BusConnects Core Bus Corridors

Kimmage to City Centre Core Bus
Corridor

Stage 1 Road Safety Audit

Document Ref: P21-026-PSW3-RP-001

3.1 Problem

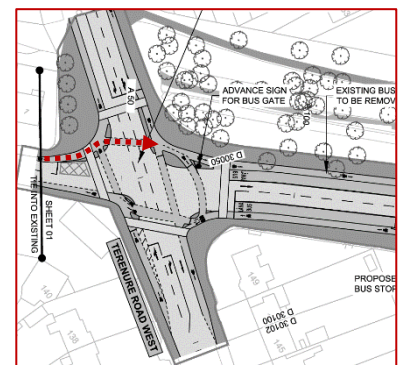
Summary: Northbound drivers may be insufficiently aware of the upcoming bus gate when entering Kimmage Road Lower, resulting in driver confusion, hesitation, and possibly unsafe U-Turn manoeuvres at the junction between Kimmage Road Lower and Ravensdale Park.

An advance sign advising drivers of the upcoming bus gate has been indicated at the junction of Kimmage Road West, Kimmage Road Lower and Terenure Road West. Additional signage has not been indicated.

The provision of a single sign in advance of the bus gate may offer limited guidance for drivers needing to choose a more appropriate alternate route, resulting in higher traffic volumes entering Kimmage Road Lower and neighbouring residential streets. This may lead to driver confusion, hesitation, and possibly unsafe U-Turn manoeuvres.

Additional advance signage should be provided on Kimmage Road West, Terenure Road West and Kimmage Road advising drivers of the bus gate & associated restrictions, and providing directions for alternate routes for intended/likely destinations.

3.1	No	No	<p>Road signs will form part of the next design stage, so the type, number and location of signs is to be developed at a later stage.</p> <p>However, it is anticipated that existing Advance Directional Signs (ADS), developed as part of the detailed design process, would be modified to identify Kimmage Road Lower as "Local Access Only".</p> <p>No other additional/dedicated Bus Gate signage is anticipated at this stage.</p>	Yes

3.2 Problem

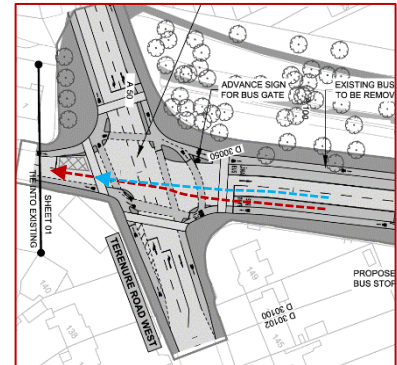
Summary: Left turning drivers may turn across straight-ahead cyclists, leading to side-swipe and side-on collisions.

The northbound cycle lane which crosses the Kimmage Road West arm of its junction with Terenure Road West, is offset from the northbound through traffic route. There is a danger that left turning drivers onto Kimmage Road West at this junction may misinterpret the cycle crossing as a separate, downstream, non-motorised road user (NMU) crossing and that they have priority over cyclists wishing to proceed northbound, resulting in possible vehicular/cyclist collisions.

During the design development the alignment of the northbound cycle lane should be amended to reduce the lateral displacement from the northbound traffic lane, in order to reduce the impression that this is a separate crossing. In addition, left turning drivers should be presented with a flashing left-arrow amber signal to ensure they enter Kimmage Road West with caution.

3.2	Yes	Yes		
3.3	Yes	Yes		
3.4	Yes	No	<p>The bus shelter will be located on the footpath rather than the island to encourage pedestrians to wait here. The floating island function here is to allow a mobility impaired person a chance to board without risk of a cyclist following behind or the bus ramp to be laid without creating a hazard to cyclists. It is not intended to accommodate waiting patrons since there is insufficient space to provide such an island.</p>	Yes

3.3 Problem

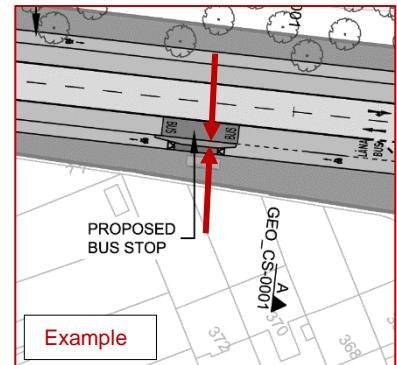
Summary: The merging of two straight-ahead traffic lanes within the junction may lead to side-swipe collisions if both movements proceed on the same phase.

No information has been provided about the proposed signal phasing at the Kimmage Road West, Terenure Road West and Kimmage Road Lower junction. Two southbound lanes are indicated at the junction, one of which is a bus lane. Should both the general traffic lane and the bus lane receive a green signal at the same time there is insufficient room on the downstream exit from the junction to accommodate two traffic lanes, possibly resulting in sideswipe collisions.

It is recommended that the bus lane and the general traffic lane operate on a separate phase, and that both lanes do not receive a green signal at the same time.

3.4 Problem

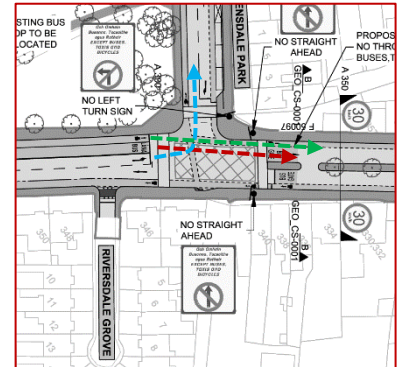
Summary: Insufficient island width may increase the risk of pedestrians, waiting for a bus, blocking the cycle track and pedestrian/cyclist collisions.

The width of the floating island is not indicated on the drawings provided, however, it appears to be narrow.

Should pedestrians waiting for a bus choose to wait within the island, there is a risk that they could impede cyclists and increase the likelihood/possibility of pedestrian/cyclist collisions.

Ensure the floating islands at bus stops along the route can safely accommodate pedestrians.

3.5 Problem

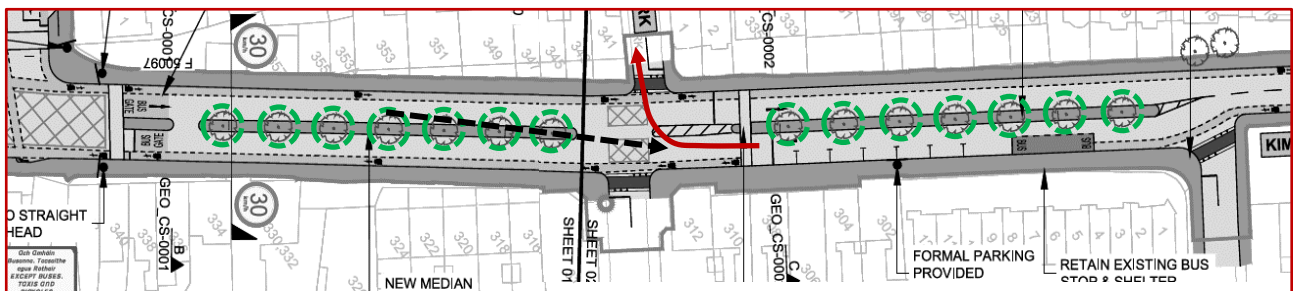
Summary: Risk of general traffic turning left across straight-ahead bus movements, resulting in side-on collisions.

No information has been provided in relation to the proposed signal phasing at the Kimmage Road Lower/Ravensdale Park junction. The junction provides northbound access for buses and cyclists through the bus gate, whilst directing general traffic to turn left into Ravensdale Park.

Should all traffic proceed on the same signal phase, there is an increased risk of side-on collisions between left turning traffic and straight-ahead buses/cyclists, resulting in side-on and vehicle/cyclist collisions.

Ensure that the general traffic lane operates on a separate signal phase to the bus and cycle lane(s).

3.6 Problem

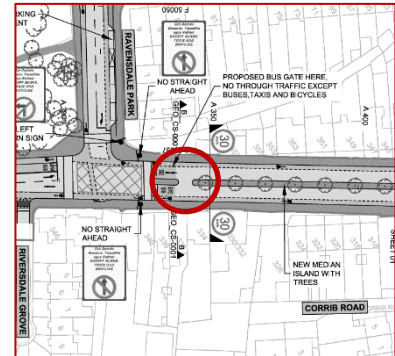
Summary: Tree planting, and associated canopies, may increase the risk of bus strikes and reduced visibility, leading to material damage and side-on collisions.

Tree planting is indicated on a new central island on Kimmage Road Lower, between Ravensdale Park and Kimmage Court. The tree canopies may, as they mature, overhang the bus corridor, increasing the risk of bus strikes and material damage collisions.

Additionally, the line of trees may reduce visibility between straight-ahead bus movement and turning traffic, leading to side-on collisions.

Care will be required during the subsequent Design Development phases to ensure that the tree species chosen have canopies, when mature, that will not present a hazard to vehicles travelling in the adjacent traffic lane and that adequate clearance is available so that forward visibility for all road users is not impeded.

3.8 Problem

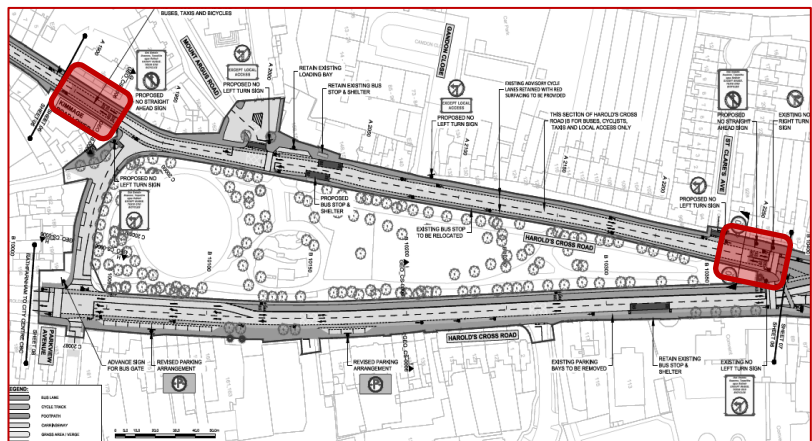
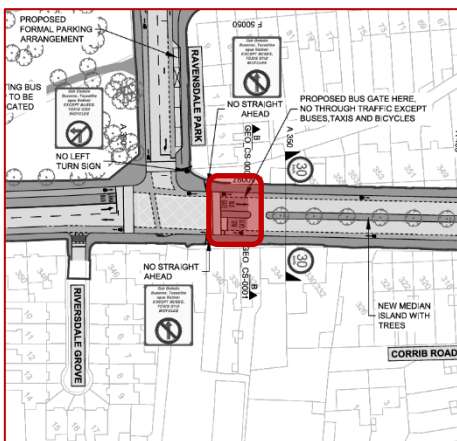
Summary: Bus gate restrictions may displace existing traffic onto the adjacent road network, giving rise to potential safety issues outside of the scheme extents.

The proposed bus gate immediately north of Ravensdale Park could result in significant volumes of traffic being displaced onto the adjacent road network, in particular to the west of Kimmage Road Lower. This displaced traffic could give rise to potential safety issues outside of the scheme extents, particularly as the adjacent road network consists primarily of residential streets.

A similar problem may exist for the bus gate indicated at Harold's Cross.

An assessment of the effect of displaced traffic on the adjacent road network should be undertaken, and measures should be implemented to address any safety issues that may arise.

3.9 Problem

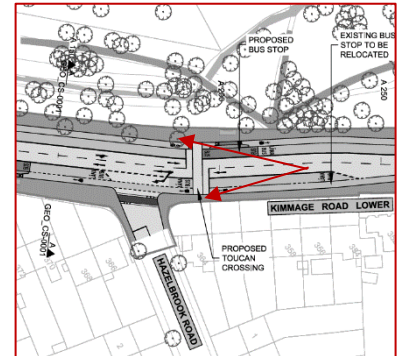
Summary: Southbound drivers may have restricted visibility to the primary and secondary signals at the Toucan Crossing on Kimmage Road Lower, leading to an increased risk of overshoot and vehicle/pedestrian collisions.

A northbound bus stop is indicated directly upstream of the Toucan crossing on Kimmage Road Lower. Stationary buses at this stop may block a southbound driver's visibility to the signal heads on approach to the Toucan crossing. Should a southbound bus also stop at the Toucan crossing, during a red signal, general traffic travelling south on Kimmage Road Lower may have no clear visibility to the primary or secondary signals, increasing the risk of overshoot and vehicle/pedestrian collisions.

The northbound bus stop should be relocated further north on Kimmage Road Lower, and appropriate signal supports chosen (e.g. high-mast or cantilever-type signals) which ensure that approaching drivers have adequate visibility to the upcoming signals.

3.10 Problem

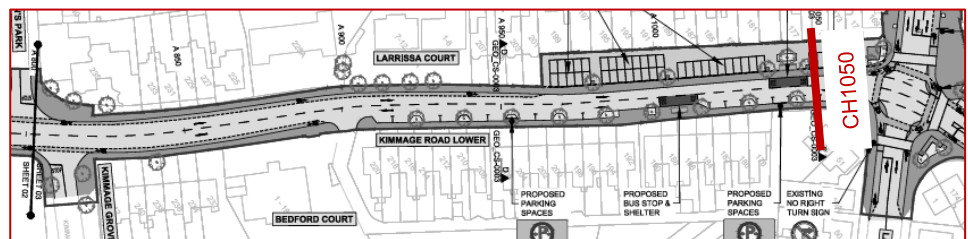
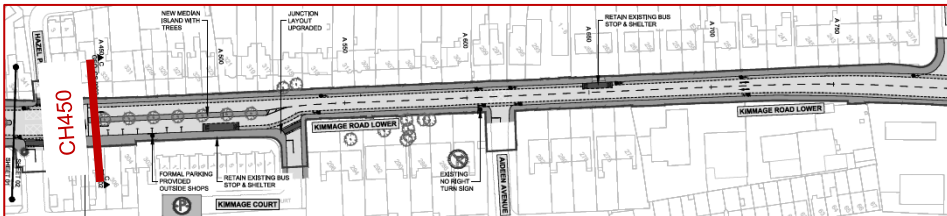
Summary: The absence of pedestrian crossing facilities on Kimmage Road Lower may lead to unsafe crossing manoeuvres and present difficulties for mobility impaired non-motorised road users.

No pedestrian crossing has been indicated along Kimmage Road Lower between the crossing at Chainage 450 and the junction with Sundrive Road at Chainage 1050. The absence of pedestrian facilities within this 600m section of Kimmage Road Lower may result in pedestrians crossing at unsafe locations, and presents difficulties for mobility impaired pedestrians undertaking return journeys by public transport.

This is a particular concern for mobility and visually impaired pedestrians, as well as bus passengers accessing opposing bus stops.

Identify pedestrian desire lines across Kimmage Road Lower and provide pedestrian facilities to support safe pedestrian movement.

3.8	Yes	Yes		
3.9	Yes	Yes		
3.10	Yes	No	<p>All existing pedestrian crossings will be maintained as part of the scheme. Minimal additional KRL works are proposed along KRL on the basis that there will be a significant reduction in traffic along the road following the implementation of the bus gates. It will be brought to the NTA and DCC's attention that a demand for additional pedestrian crossing points should be monitored and provided in future if required.</p>	Yes

3.11 Problem

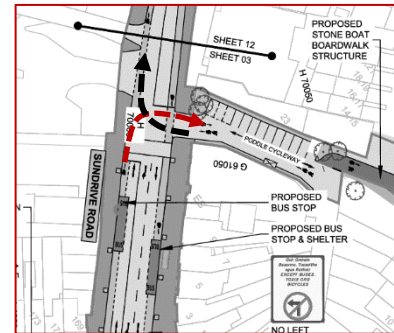
Summary: Risk of vehicle/cyclist collisions where right turning cyclists' cross traffic on Sundrive Road to access/exit the Poddle cycleway.

It is unclear if it is intended to signalise the intersection between Sundrive Road and the Poddle cycleway. A failure to signalise this junction could result in difficulties for cyclists entering/exiting the Poddle cycleway, particularly for those undertaking right turns into/out of the cycleway.

The Poddle access at Mount Argus Way should be incorporated within the signal arrangement indicated on Sundrive Road.

3.12 Problem

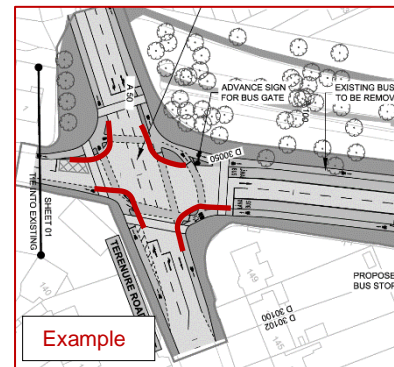
Summary: Modifications to junction radii may increase the risk of large vehicles mounting the kerb, leading to vehicle/pedestrian, vehicle/cyclist and material damage collisions.

Junctions within the Scheme extents are being modified to incorporate protected cycleway lanes/tracks. This shall result in junctions having tighter radii, which may complicate the swept path of a large vehicle turning through the junction, and increase the risk of kerb strikes, vehicle/pedestrian, vehicle/cyclist, and material damage collisions.

A swept-path analysis should be undertaken at each junction to confirm that large vehicle movements can be accommodated safely.

3.13 Problem

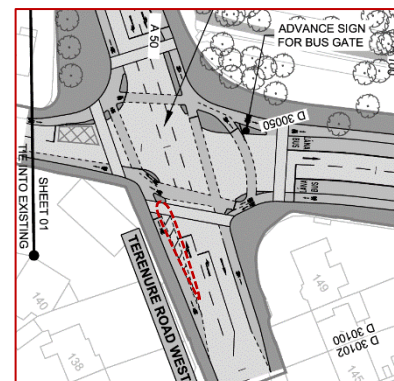
Summary: Ghost island may fail to direct drivers around the kerb island at the junction, leading to vehicles mounting the kerb, vehicle/pedestrian, vehicle/cyclist and material damage collisions.

A ghost island has been indicated on Terenure Road West, upstream of a physical island at the junction. Drivers may fail to see the road markings during the hours of darkness, in poor weather, or if the markings become worn over time. This may increase the risk of westbound drivers proceeding through the junction without being fully aware of the physical island, leading to vehicles mounting the kerb and vehicle/pedestrian, vehicle/cyclist or material damage collisions.

The ghost island should be replaced by a physical island with an appropriate sign/bollard within the 'nosing'.

3.11	Yes	Yes		
3.12	Yes	Yes		
3.13	Yes	No	<p>A physical island cannot be placed along the full extent highlighted since access is required to the petrol station forecourt across this hatch. It may be possible to provide pencil</p>	Yes

3.14 Problem

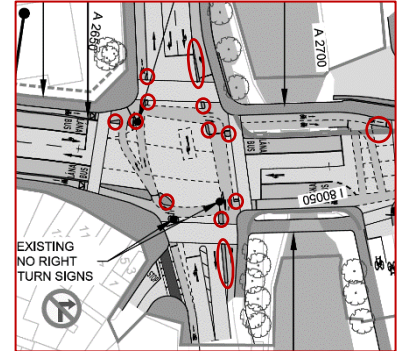
Summary: Small islands proposed at signalised junctions may be impractical to sign, and lead to these islands being struck.

Small islands have been indicated within signalised junctions to separate vehicle, cycle and pedestrian movements. The relatively small size of the islands, and their number within a junction, may be impractical to sign, and lead to these signs being struck by vehicles and cyclists, leading to material damage and loss of control collisions.

Ensure physical islands can accommodate traffic signs and provide at least 450mm between the kerb and sign edge.

3.15 Problem

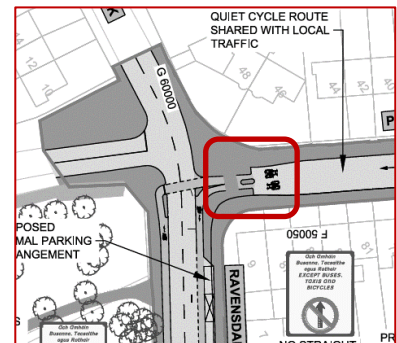
Summary: Large vehicles (such as Refuse Vehicles) may reverse over a lengthy distance on Poddle Park, increasing the risk of material damage collisions.

The Poddle Park junction with Ravensdale Park is indicated as being closed. Southbound drivers on Poddle Park will need to undertake a U-turn at the closure, before returning north.

No turning head facility has been indicated at this location, which may require large vehicles (e.g. refuse vehicles) to reverse long distances to a turning point. This may increase the risk of material damage collisions.

Provide a turning head facility at the Poddle Park/Ravensdale Park junction and undertake analysis to confirm the swept path of a turning vehicle can be safely accommodated.

3.14	Yes	Yes		
3.15	No	No	Refuse trucks regularly reverse along residential roads where provisions for turning are constrained. There is a wide commercial access approximately 70m north of the proposed traffic plug which can act as a turning point for vehicles and requires a short reversing distance.	Yes

3.16 Problem

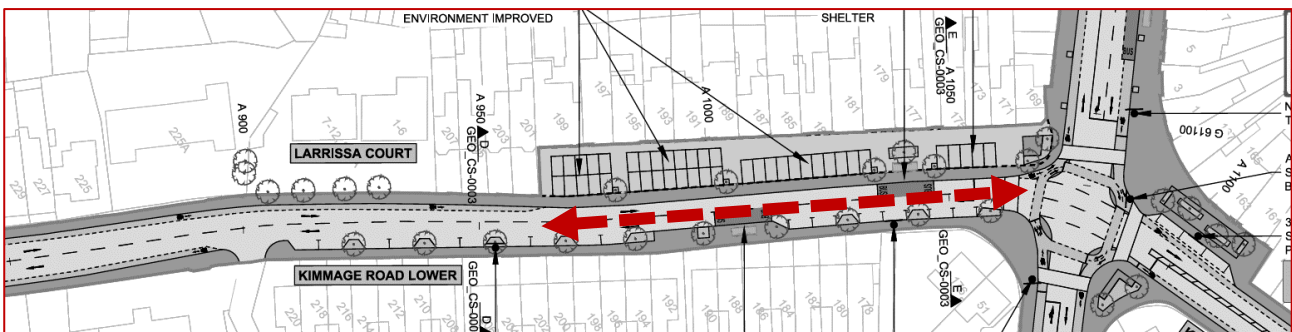
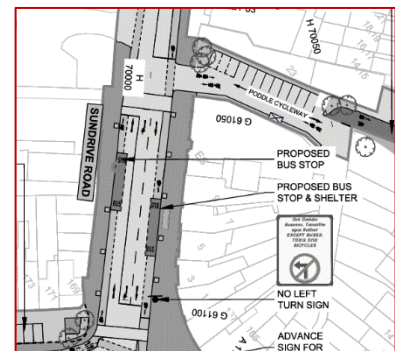
Summary: The removal of approximately 100m of advisory cycle lanes on Kimmage Road Lower may increase the risk of a vehicle/cyclist collision.

it is proposed to remove a section of an existing advisory cycle track on either side of Kimmage Road Lower between Sundrive Road and a point 100m to the south. The removal of cycle infrastructure in this area, particularly where significant on and off-street parking exists, may complicate the interaction between drivers and cyclists, and increase the risk of vehicle/cyclist collisions.

Either: -

- Remove the on-street parking and retain the existing advisory cycle lanes; or
- Provide a shared-surface with traffic calming (e.g. raised tables), surface treatment, signage and road markings to ensure that cyclists and vehicles can safely use the same carriageway.

3.16	No	No	The proposed bus gate just north of Ravensdale Park will act as traffic management along KRL, reducing the traffic volumes to appropriate levels in line with NCM guidelines for allowing cyclists to share with general traffic. The vehicular parking is required to formalise the residential parking activities in the area which currently occur within the existing cycle lanes. Removing the parking will encourage such parking activities to continue, forcing cyclists to weave in and out of the cycle lane creating a more hazardous situation than is proposed. Raised tables are not desirable from a bus operation point of view and there are no statutory signs for shared areas.	Yes

3.17 Problem

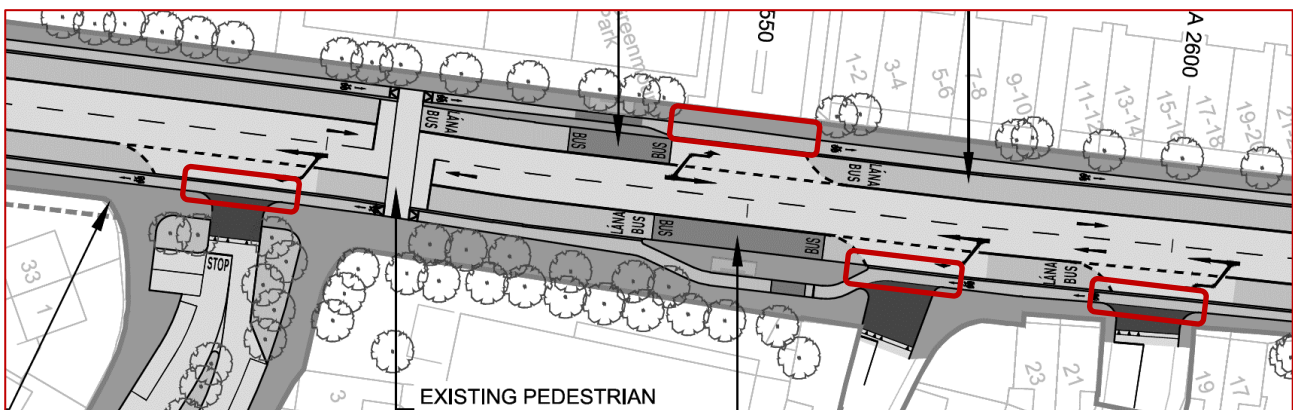
Summary: Stationary buses at the bus stop on Sundrive Road may block visibility to the primary signal head, leading to unsafe overtaking and vehicle/pedestrian collisions.

The bus stop on Sundrive Road is located upstream of a signalised pedestrian crossing. Drivers may wish to overtake buses at the bus stop, and accelerate to move past the stationary bus with limited visibility to the traffic signal head. This may increase the risk of a driver failing to observe a red signal, and continue through the crossing on a pedestrian phase, leading to vehicle/pedestrian collisions.

Ensure drivers have sufficient visibility to the pedestrian signals when a bus is at the bus stop, or amend the layout at this location to prevent vehicles from passing stationary buses at the bus stop.

3.17	Yes	No	The pedestrian crossing will be relocated across the northern arm and the southern stop line extended further from the bus stop.	Yes

3.18 Problem

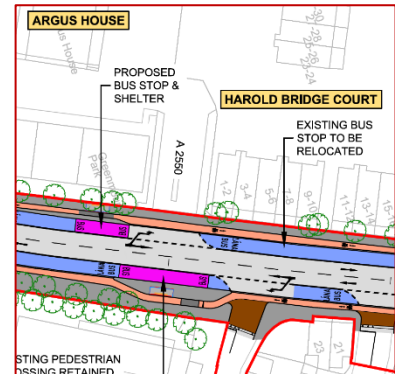
Summary: Unclear priority between straight-ahead cyclists and vehicles turning into/out of side roads could lead to side-on collisions.

The off-road cycle track is indicated as continuing through side road junctions. Drivers may believe cyclists are on the footway, so would need to yield to turning drivers on the road. Similarly, cyclists may believe they have priority as the cycle track is continuous across the side road junction.

As a result, both cyclists and drivers may be confused as to who has priority at the side road, increasing the risk of side-on collisions between vehicles and cyclists.

The off-road cycle track should be ramped back to the carriageway level upstream of a side road junction, thereby providing clarity that straight-ahead cyclists have priority at side road junctions.

3.18	No	No	Drivers will need to mount over a 60mm high splayed kerb at junctions indicating the priority for cyclists across these junctions.	Yes
3.19	Yes	No	There is in sufficient road cross-section available to provide a floating island north of the access. The bus cage will be moved further south of the access to improve the visibility for exiting drivers and for bus drivers of right turning vehicles into the access.	Yes

3.20 Problem

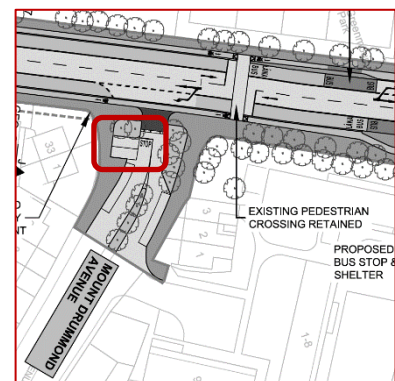
Summary: Vehicles using the perpendicular parking spaces on Mount Drummond Avenue may exit in front of a vehicle or cyclist using the junction, leading to side-on collisions.

Two perpendicular parking spaces have been indicated at the junction between Harold's Cross Road and Mount Drummond Avenue. Given the close proximity of the perpendicular parking spaces to the side road junction, there is an increased risk of drivers exiting the parking spaces with limited visibility to vehicles or cyclists using the junction.

This may lead to side-on collisions where a driver exits the parking spaces in front of a cyclist or vehicle.

The perpendicular parking spaces should be removed.

3.20	No	No	The parking spaces are located at the required set back from a junction location. The parking provision is as per DMURS recommendation to narrow the excessively wide existing street.	Yes

3.21 Problem

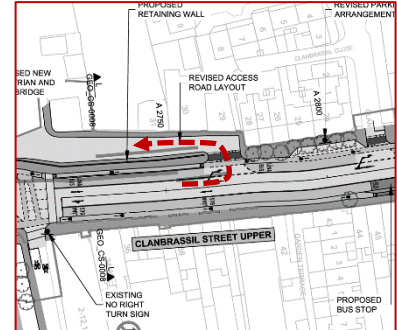
Summary: Acute angle of side road at CH2750 may lead to complex entry/exit manoeuvres, and poor visibility.

The side road at Ch. 2750 meets Clanbrassil Street Upper at an acute angle. This may complicate manoeuvres for vehicles entering/exiting the access, and restrict visibility for exiting drivers, increasing the risk of side-on and material damage collisions.

Additionally, the retaining wall indicated at the side road access may also block inter-visibility between exiting drivers and pedestrians/cyclists, increasing the risk of vehicle/pedestrian and vehicle/cyclist collisions.

Undertake swept path analysis to confirm that vehicles can safely enter/exit the side road, and ensure sufficient inter-visibility is available between all road users at this junction.

3.22 Problem

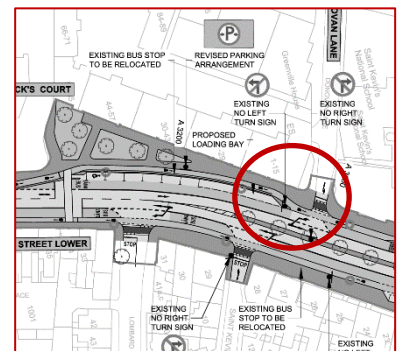
Summary: The cycle track may be used for loading/unloading, forcing cyclists into the path of pedestrians, leading to personal injury collisions.

The cycle track is directed behind parking bays and a loading bay at Ch. 3200. Loading/unloading operations could result in the cycle track being impeded, leading to cyclists entering the footway where they may conflict with pedestrians, resulting in personal injury collisions.

Additionally, the parking/loading bays may reduce visibility for drivers exiting Donovan Lane, increasing the risk of side-on collisions.

The cycle track should be relocated in front of the parking bays, which is consistent with other cycle track/parking arrangements within the scheme extents.

3.21	Yes	Yes		
3.22	Yes	No	The designer shall investigate opportunities to create a wider buffer zone between the parking bay and the cycle track to accommodate loading activity, which should reduce the risk of loading crates and/or trollies obstructing the path of cyclists. The exact width will be developed further at the detail design stage, ahead of a Stage 2 RSA.	Yes
